Interactive comment on “QUAL-NET, a high temporal resolution eutrophication model in large hydrographic networks” by Camille Minaudo et al.

Received and published: 25 January 2018

Fig. 1. Figure A8. Water temperature estimated with T-NET module. Temporal variations at S2 (top) and Lagrangian view from S1 to S2 in summer

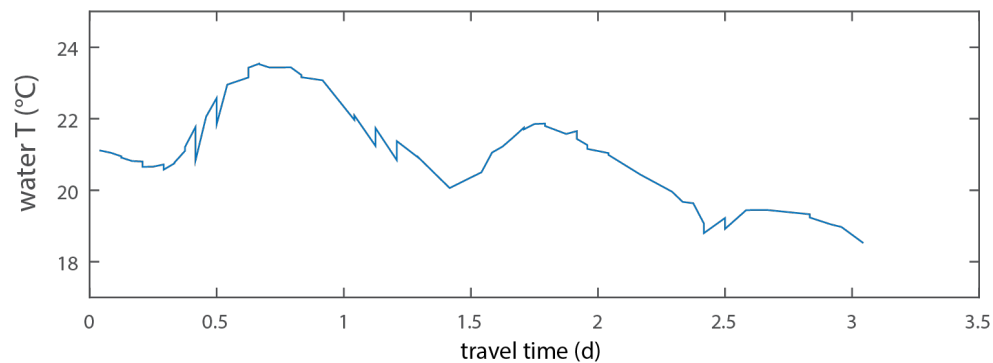
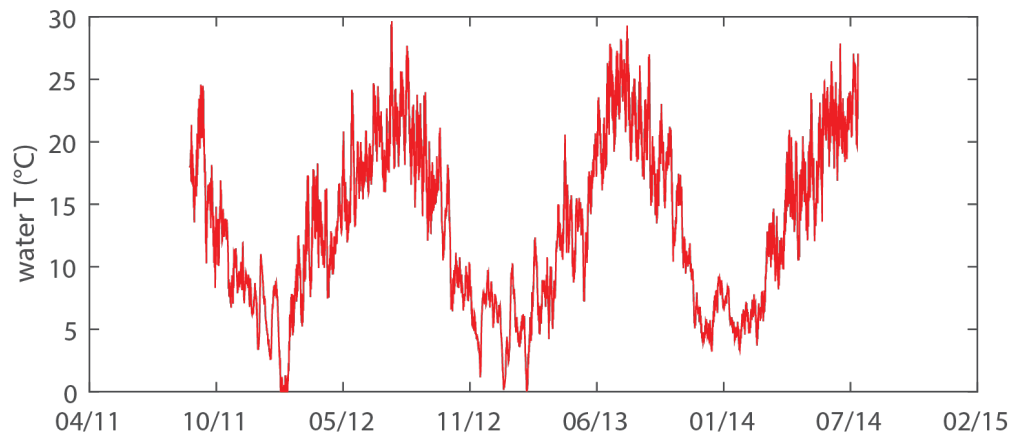
//— R2C3: The manuscript states that most of biogeochemical processes are water temperature dependent, however, I found that it does not provide modeling result on temperature variable. How does the daily temperature look like? During the travel time from S1 to S2, does it highly fluctuated? During summer, does the temperature at S2 close to the temperature value at S1?

//— A: That is correct. We agree that presenting results of water temperature estimations is necessary. Water temperature was highly seasonal and fluctuates between 0 and 30°C (Figure A8). In summer in the Loire River, amplitude of diel cycles ranged between 0.2 and 1.5°C. Seasonal variations between S1 and S2 were very close (Figure A9). Temperature variations at the daily scale were highly contrasted at the two stations, highlighting meteorological and hydrological controls on water temperature.
